Service Bulletin

Alternator Control Unit (ACU) Replacement & ACU Interface Replacement.

SB-GA8-2017-171

Issue 2

Figure 10 – Wiring diagram with replacement of Zeftronics alternator control unit for SB-GA8-2014-118.

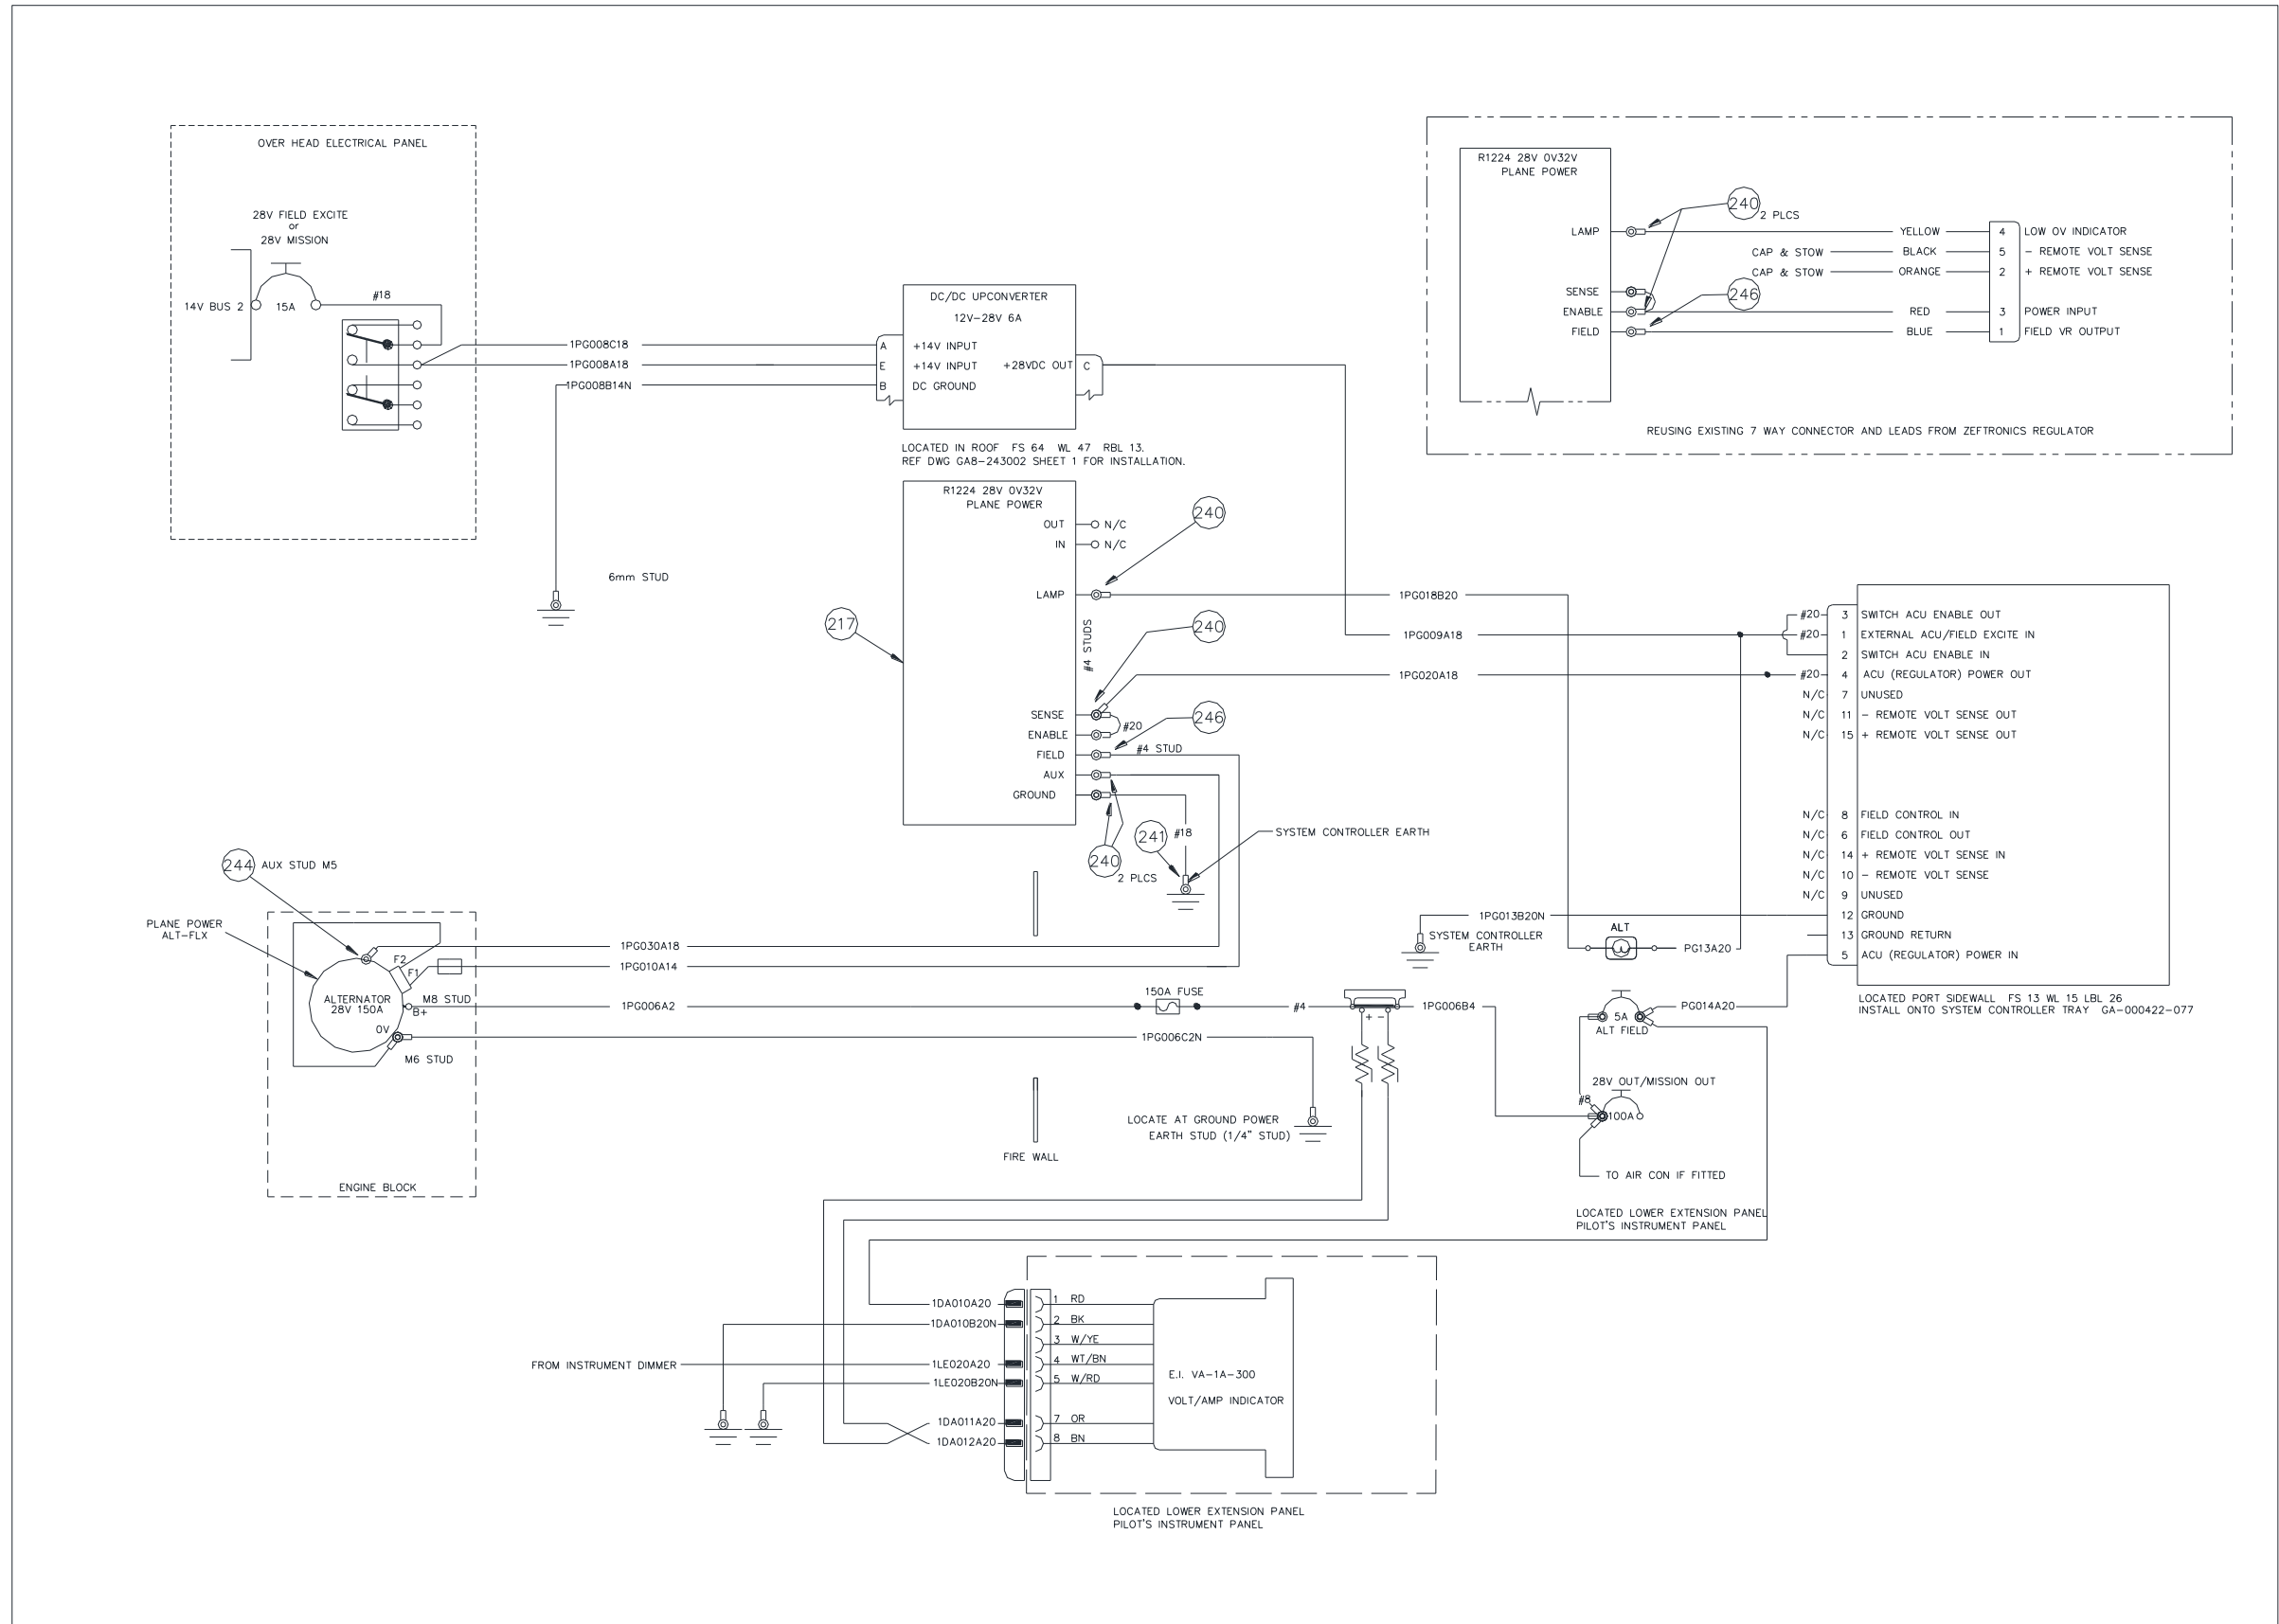
Issue 2: Wiring for 100A alternator AUX terminal revised. Fuse holder part number corrected. Ref GAE11#2074

18. Attach the R1224 Voltage Regulator in accordance with Figure 4.
19. Re-wire the aircraft to the R1224 Voltage Regulator in accordance with Figure 9, Figure 10 or Figure 12 as applicable (Refer to Table 6). Attention is drawn to the installation of an AUX circuit as described in Figure 10 or Figure 12.

Figure 11 – Wiring diagram with replacement of Zeftronics alternator control unit for SB-GA8-2014-118 & removal of DC/DC Up-Converter.

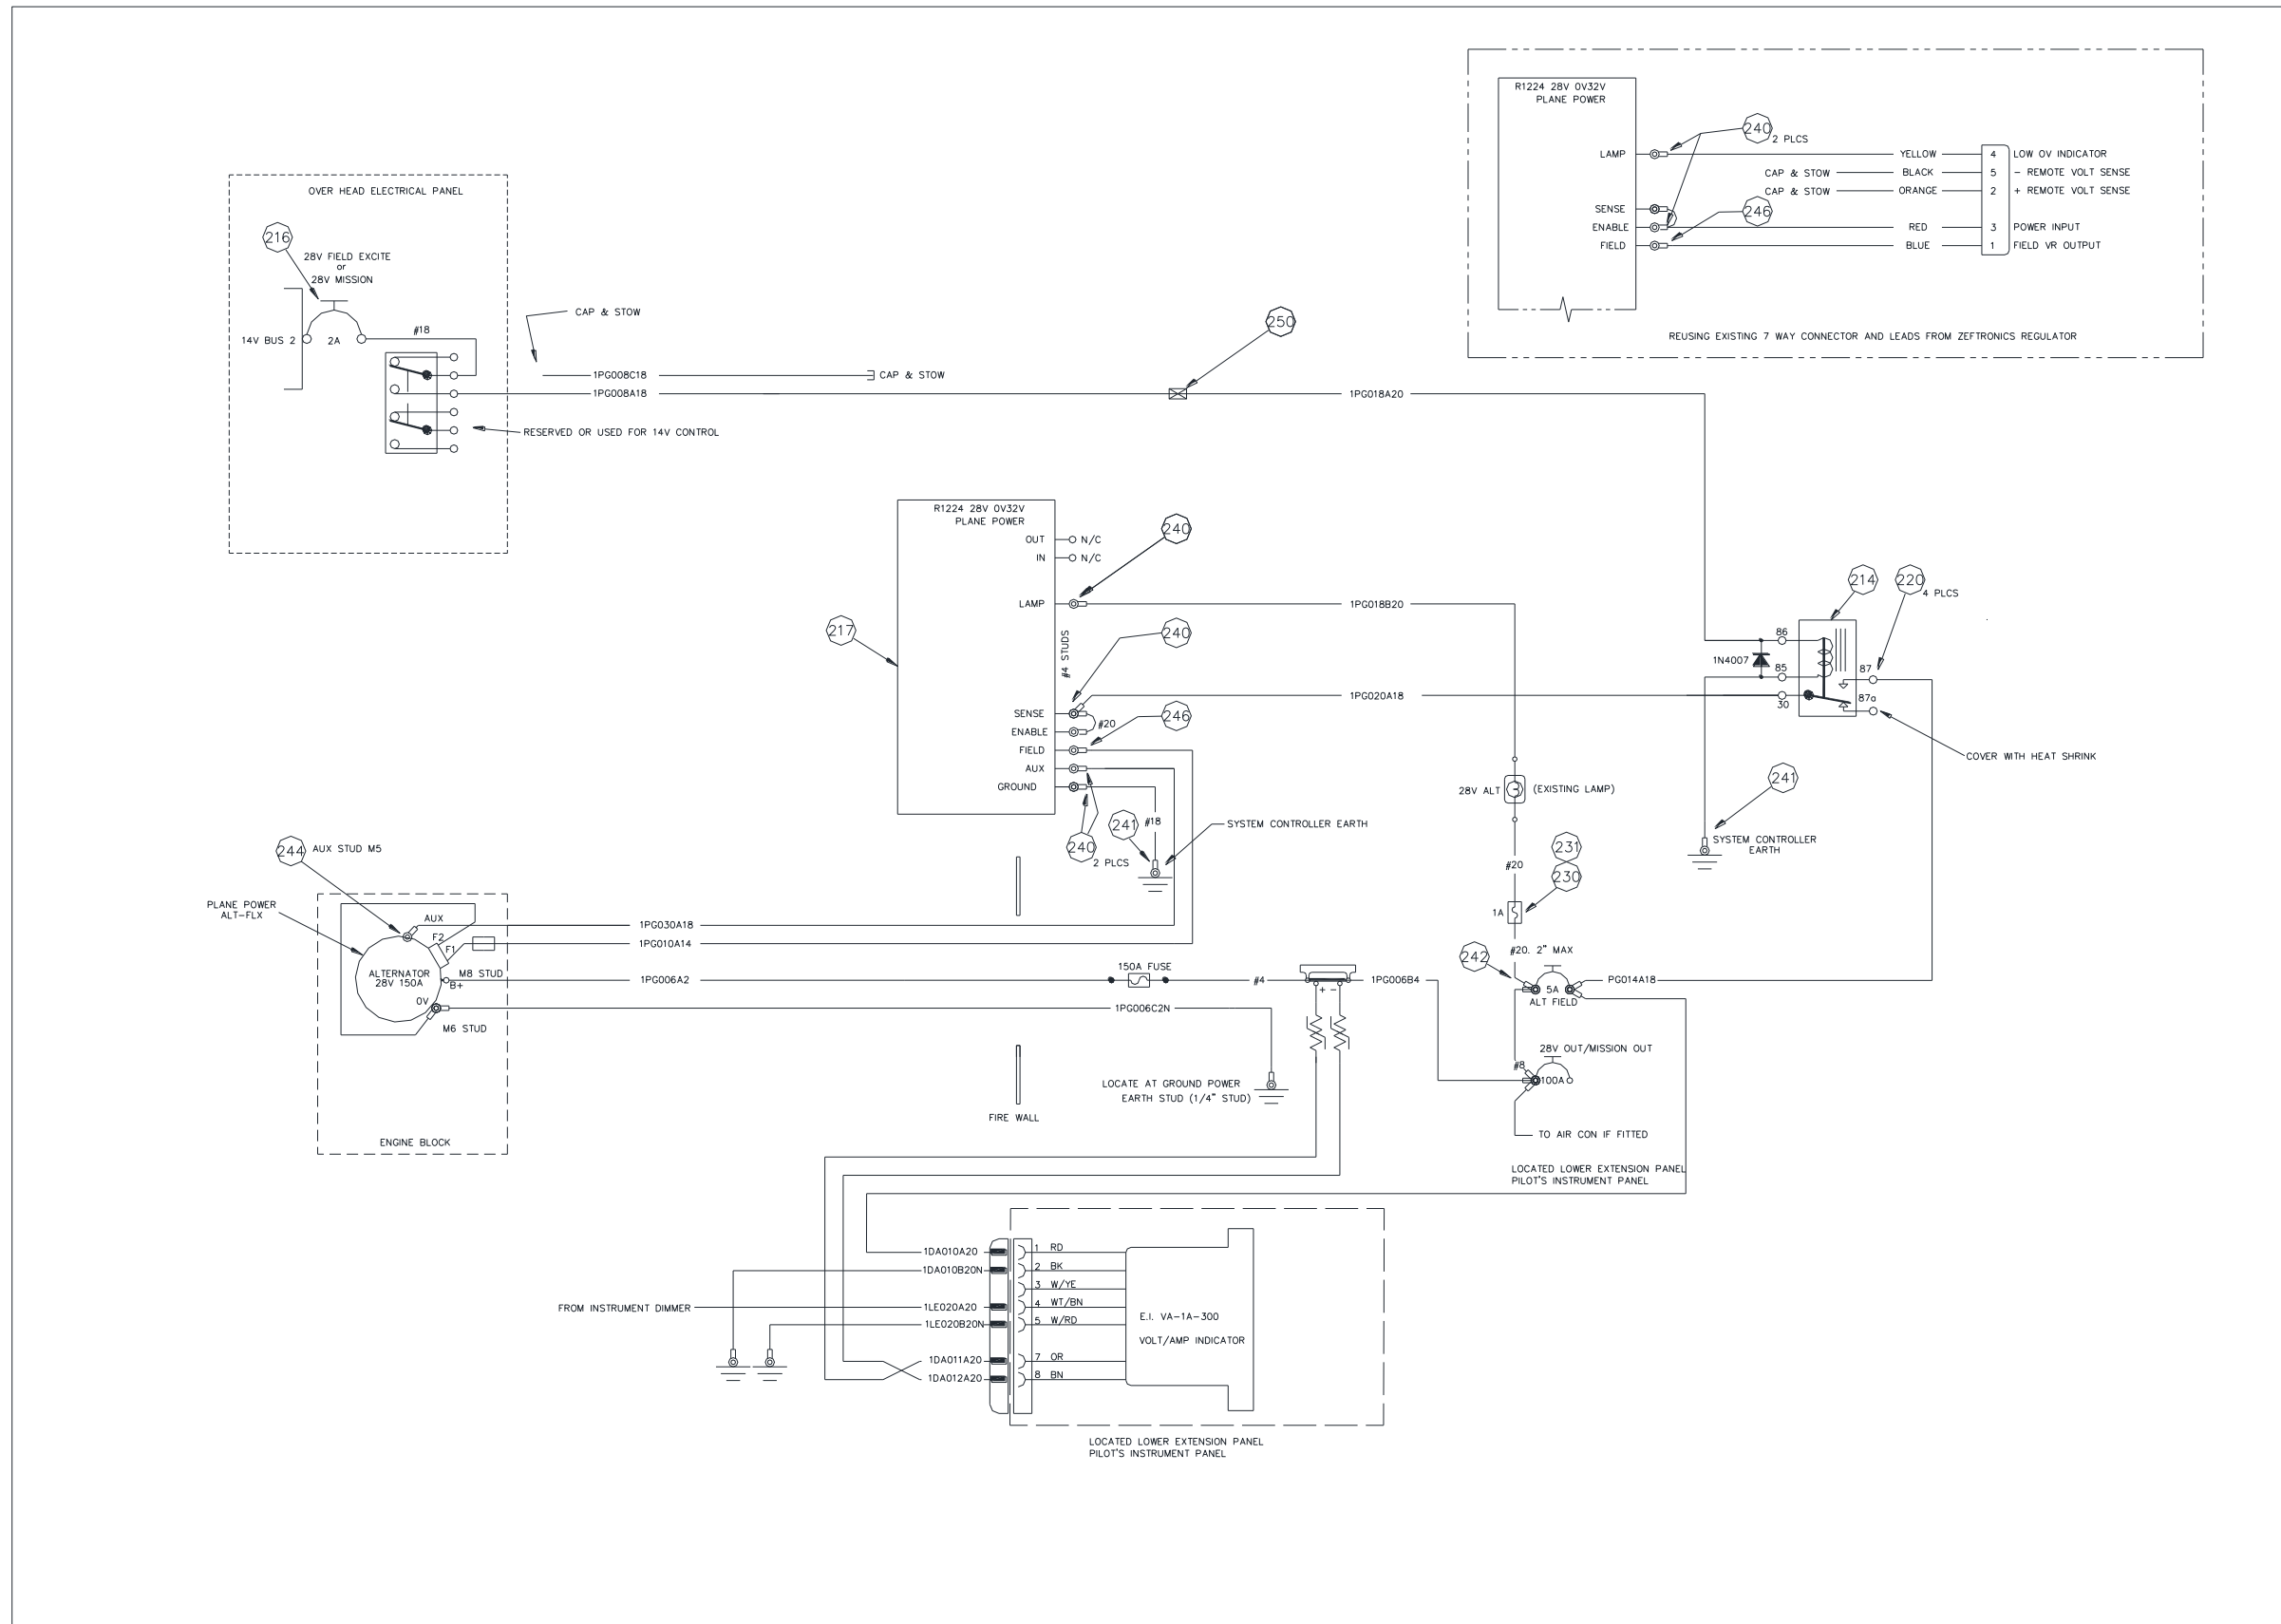
23. Re-wire the aircraft to the R1224 Voltage Regulator and Change-Over Relay in accordance with Figure 11 for the Plane Power ALT-FLX alternator or Figure 13 for the ES-14024B-2 alternator. Attention is drawn to the installation of the AUX circuit.
